AGENDA

CITY OF OPELIKA
HISTORIC PRESERVATION COMMISSION
December 8, 2022
4:30 p.m.
Meeting Chambers at Opelika Municipal Courtroom
300 MLK Boulevard

**City of Opelika
Historic Preservation Commission
Staff Report**

Agenda Item #: 1
Meeting Date: 12/08/22
Action Requested: COA: Replace rear windows and door; Install awning over rear door
Location of Property: 108 S. 8th St; Downtown Historic District
Petitioner: Opelika Main Street

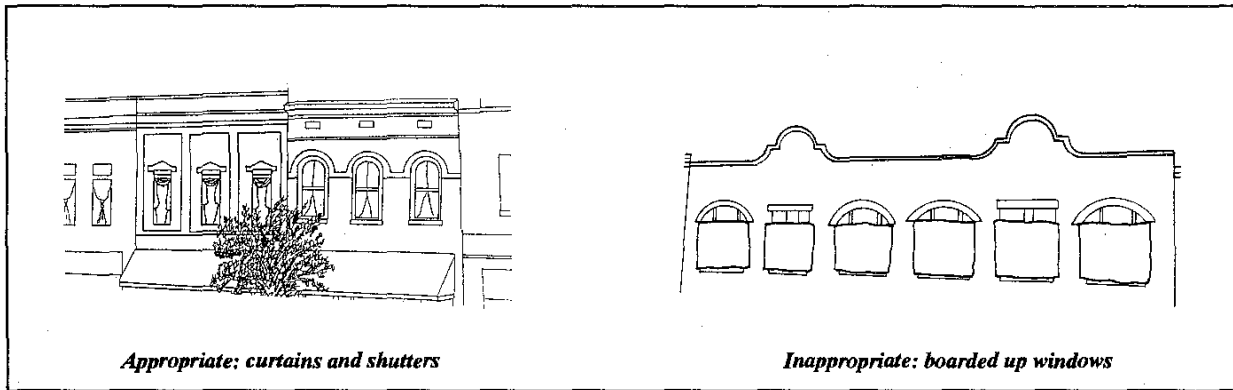
1. Install new wood windows with exterior SDL bars in existing window spaces.
2. Replace rear door with wood door with Exterior SDL bars and tempered glass.
3. Install flat metal awning over rear door to match front awning.

- 1 Staff recommends approval of wood windows with SDL grids or rear.
- 2 Staff recommends approval of wood door with SDL grids on rear.
- 3 Staff recommends approval of flat metal awning with rods.

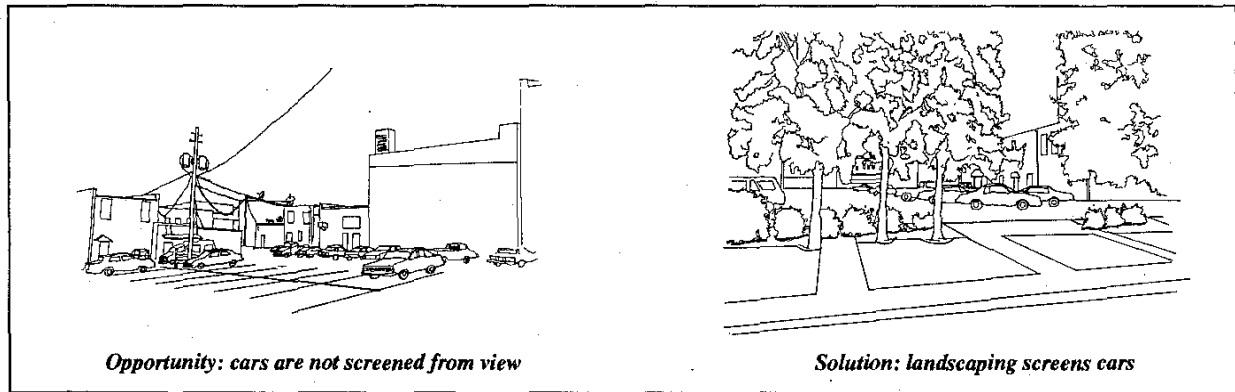
1. Gravel parking on side of lot to include five (5) spaces. Shrubs will screen the parking area from the road.
2. Install wood shutters half width of window opening.

1. *Staff recommends approval of graveled parking with shrub screening.*
2. *Staff recommends approval of wood shutters.*

Parking site plan

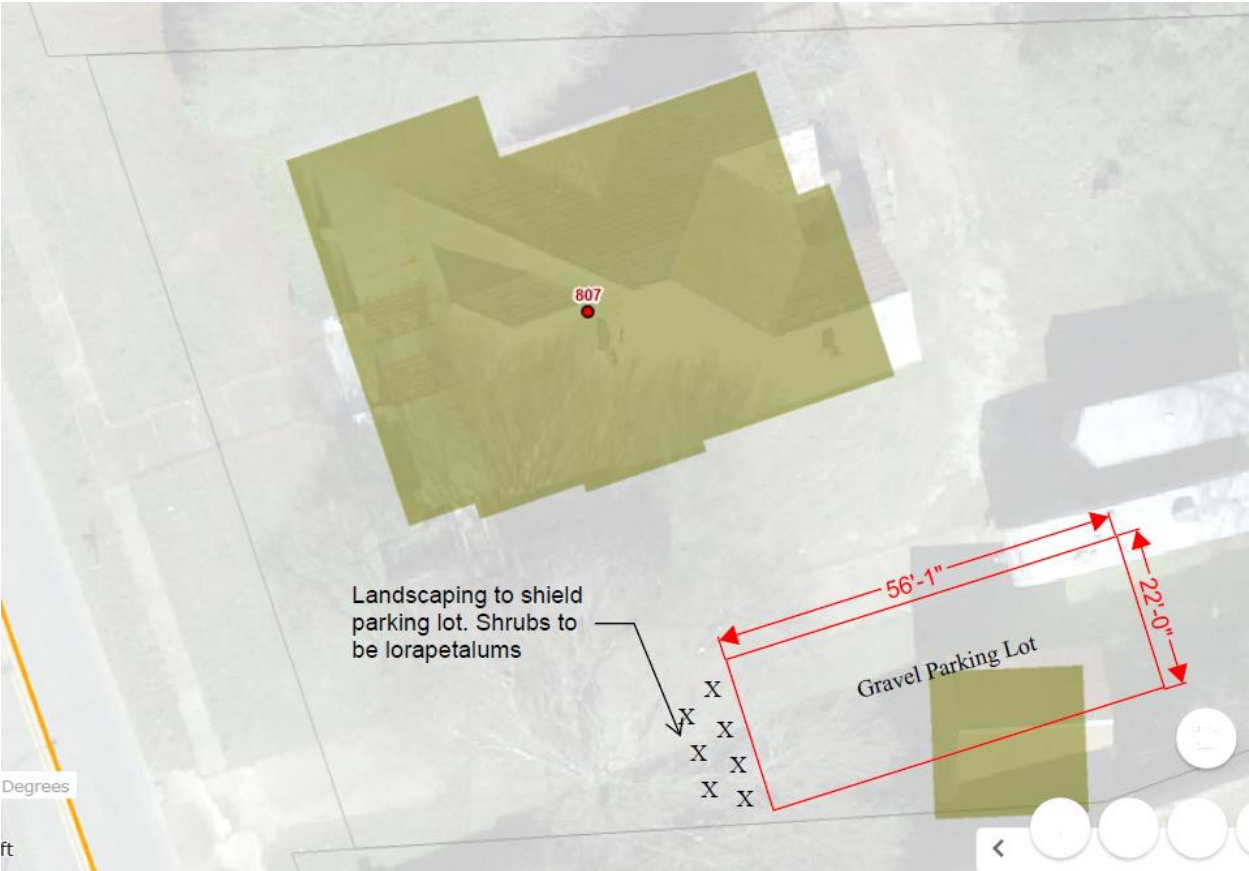
Shed has been demolished and site prepped for parking area.
